**LIBERTY TREE ACADEMY**  
**FINAL DRAINAGE REPORT**

Project Number: 18.995.001

**PPR-18-023**

FIGURE A-2. EXISTING DRAINAGE PLAN

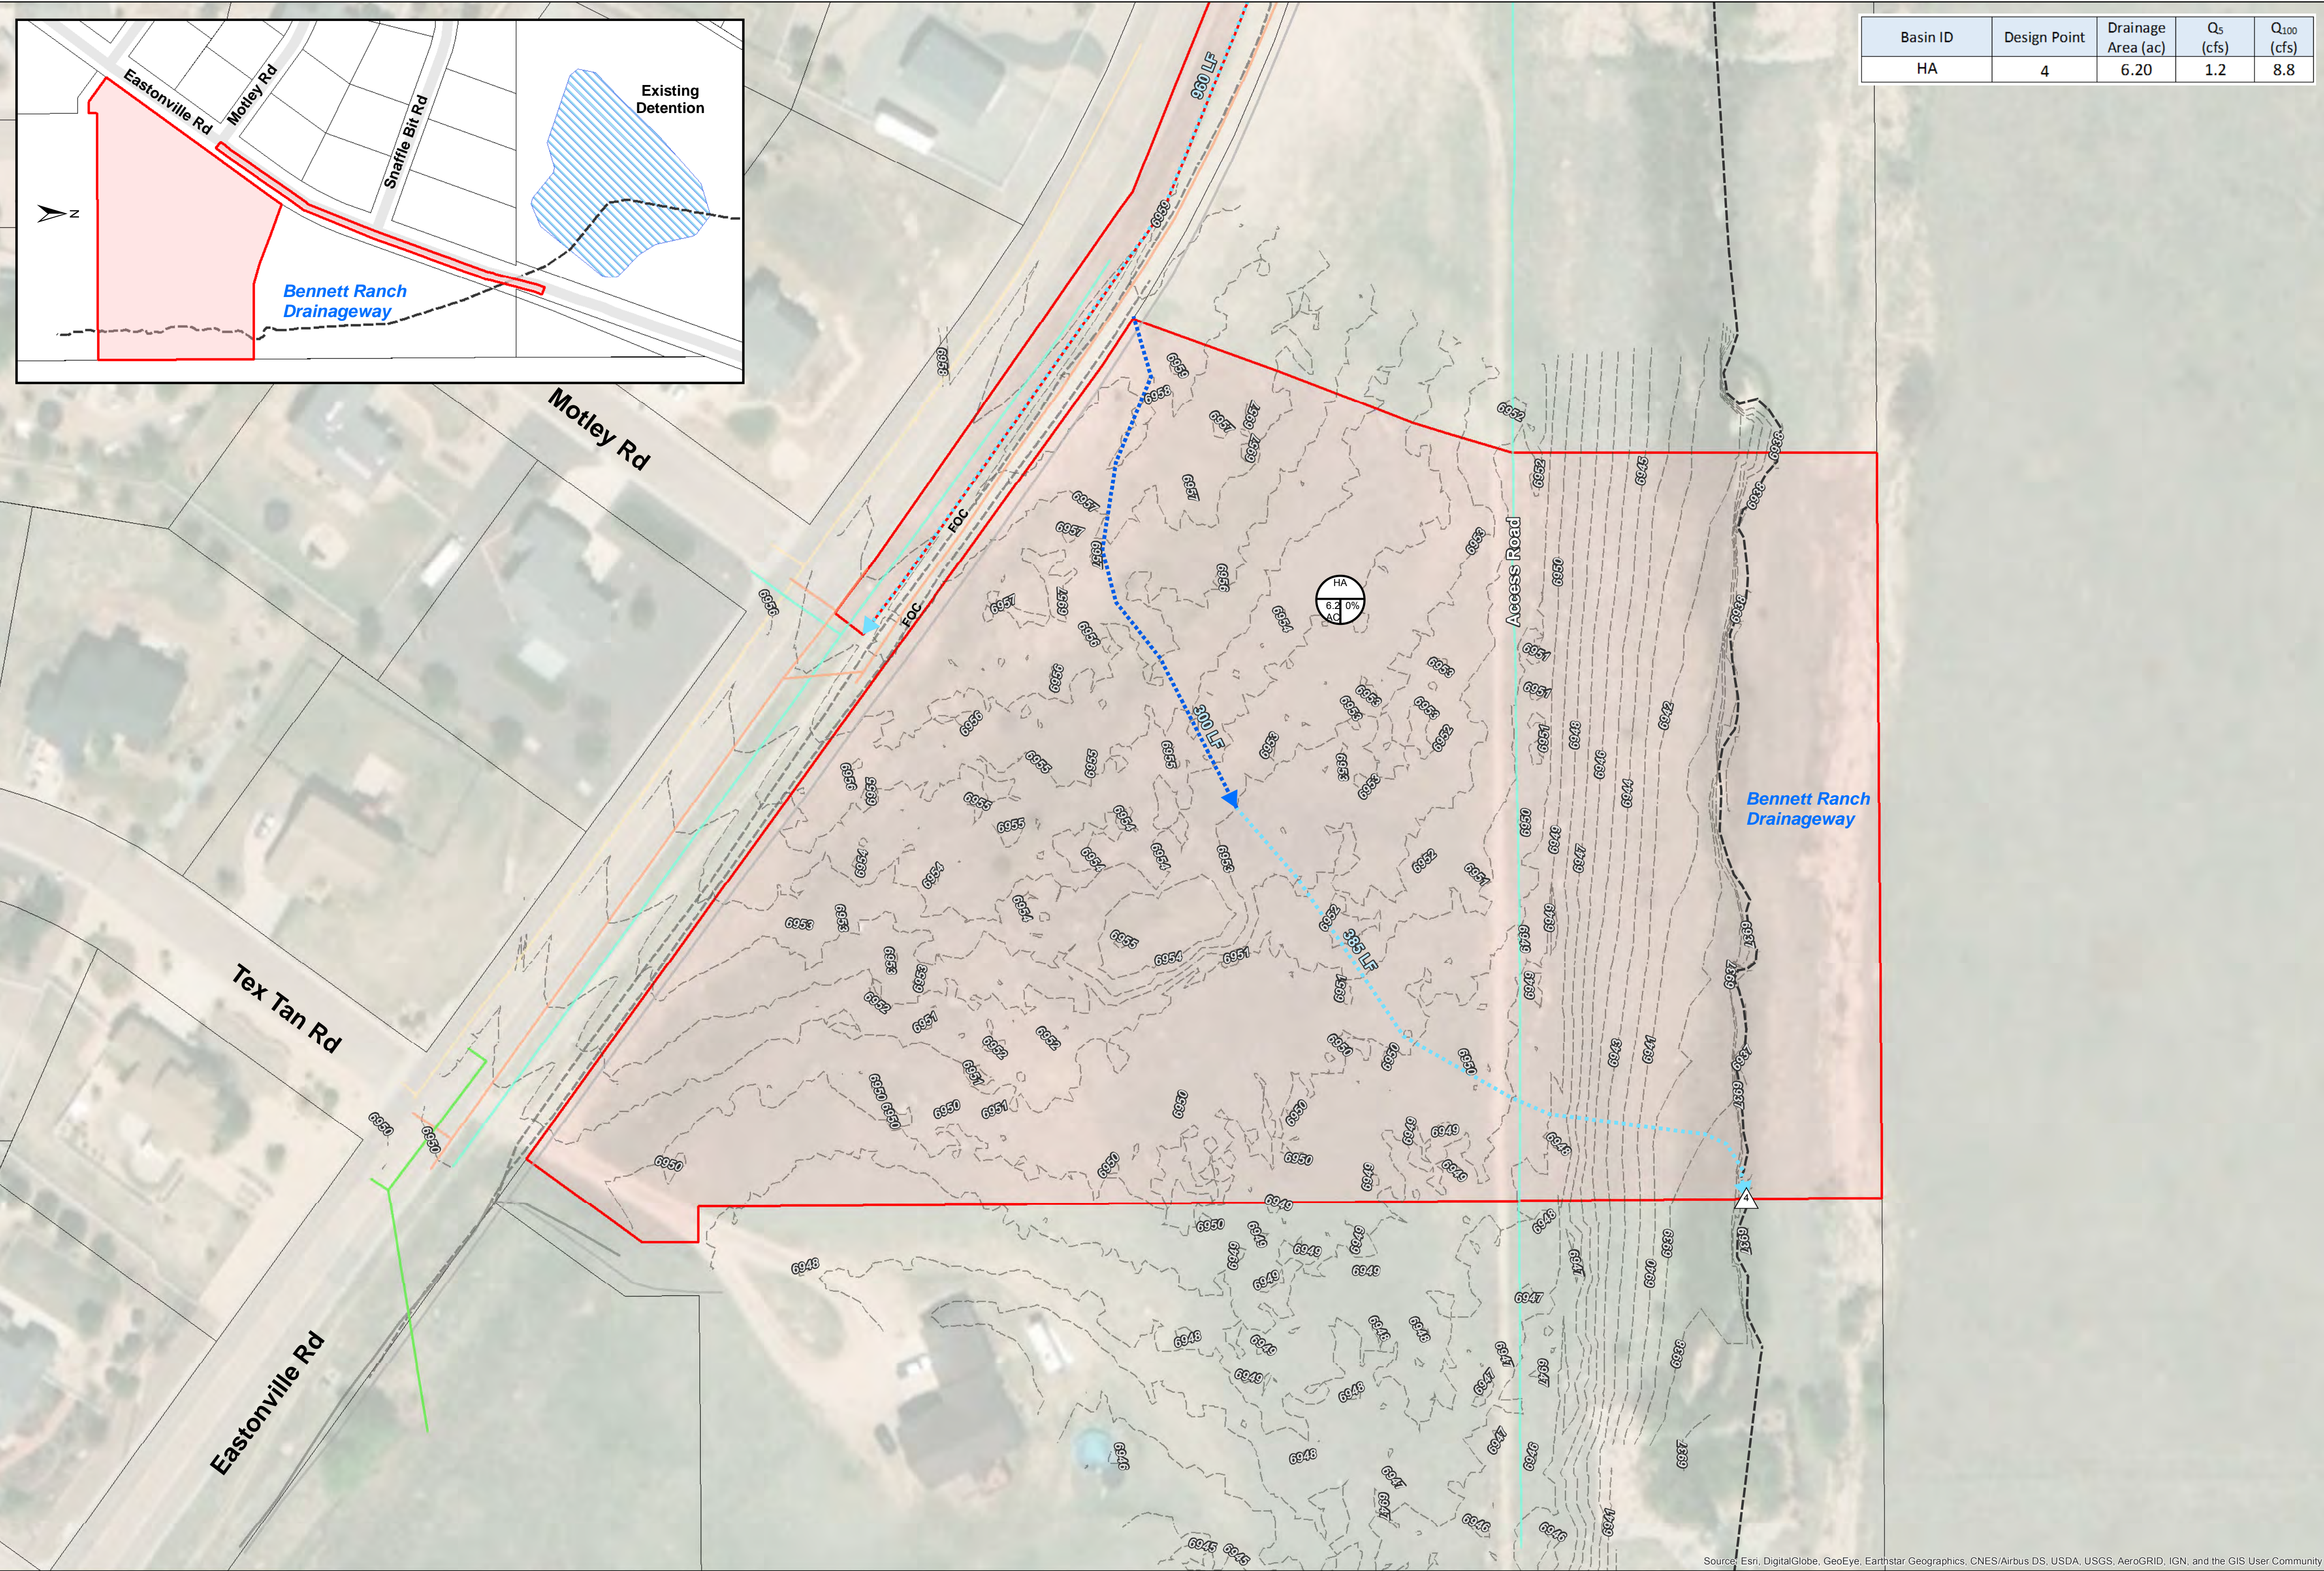
The plan image has apparently shifted  
Southwest on the aerial still showing  
impacts to the existing driveway.

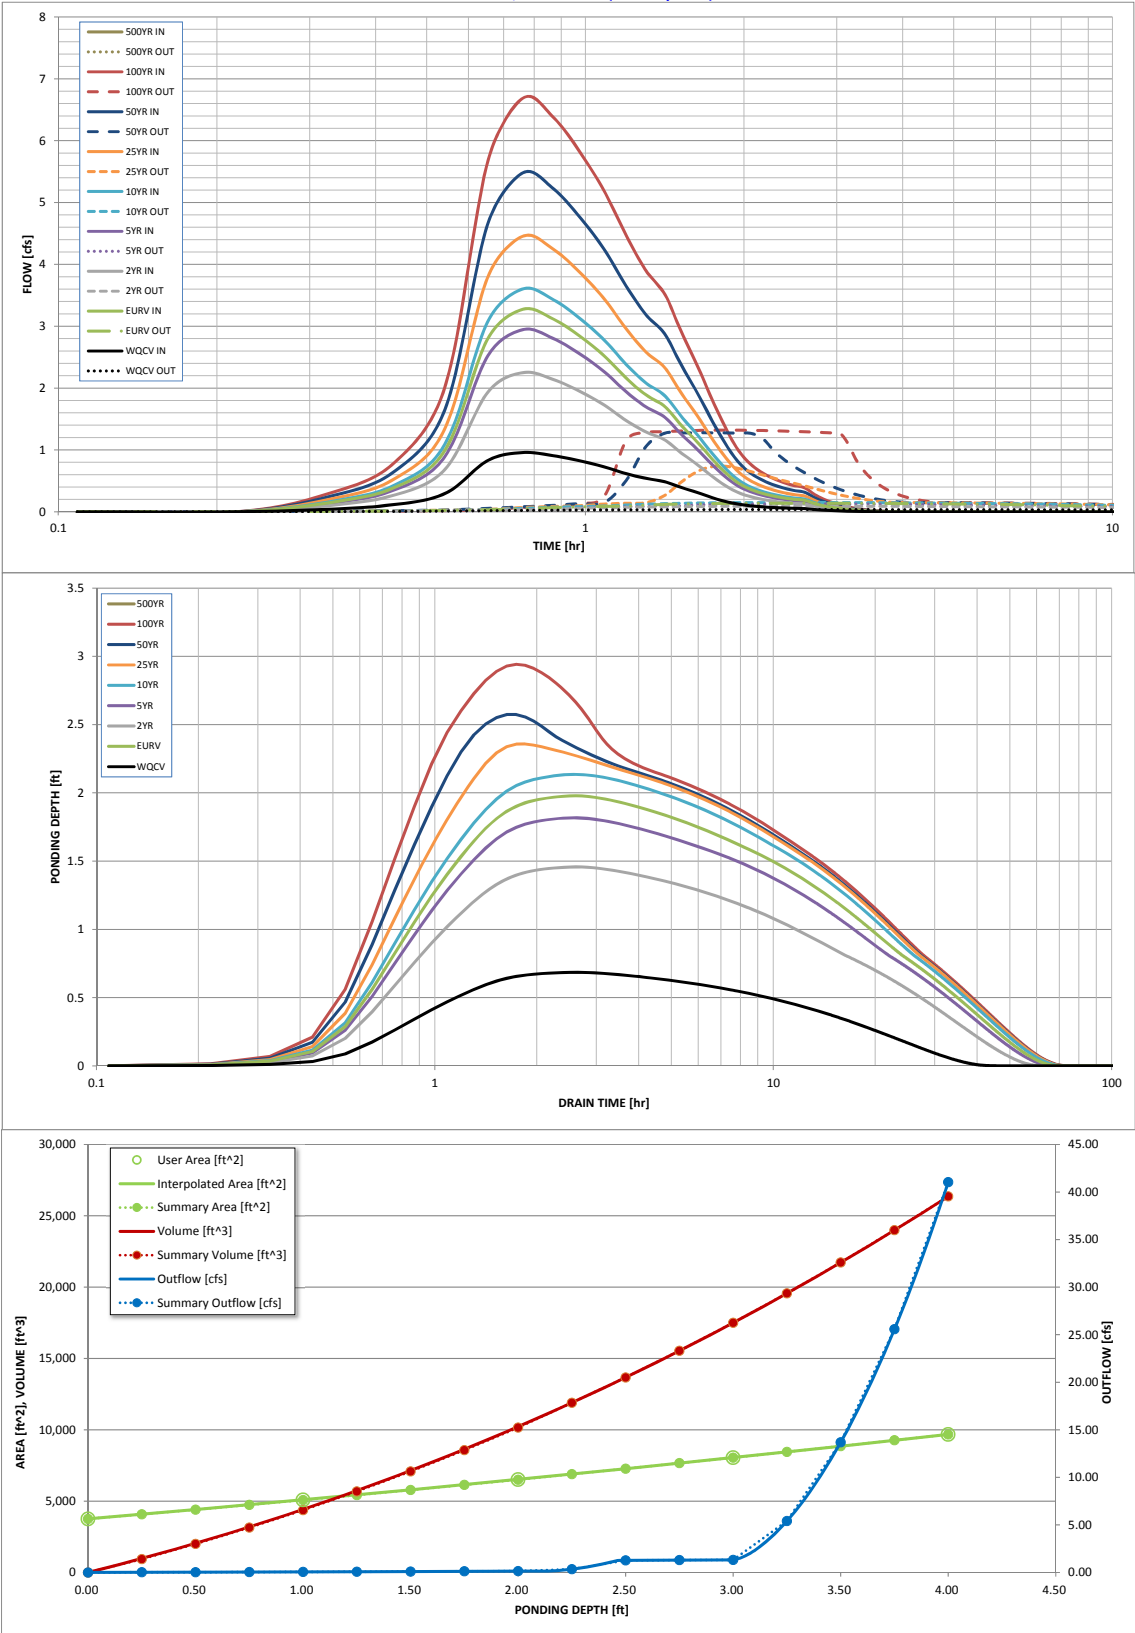
Depth to Invert does not match the construction drawings.

Per UDFCD full spectrum detention facility is designed to reduce the developed condition 100yr peak discharge to 90% of the pre-development 100-yr peak flow rate.

Updated. Estimated predevelopment peak flows are very small (0.015 cfs to 0.56 cfs) in the 5-yr through 50-yr events due to the small tributary basin areas, which causes developed outflows to be higher than predeveloped inflows in these events. The proposed 50-yr release rate is only 1.2 cfs, however. Decreasing the release rate further would cause retention for more than 72 hours.
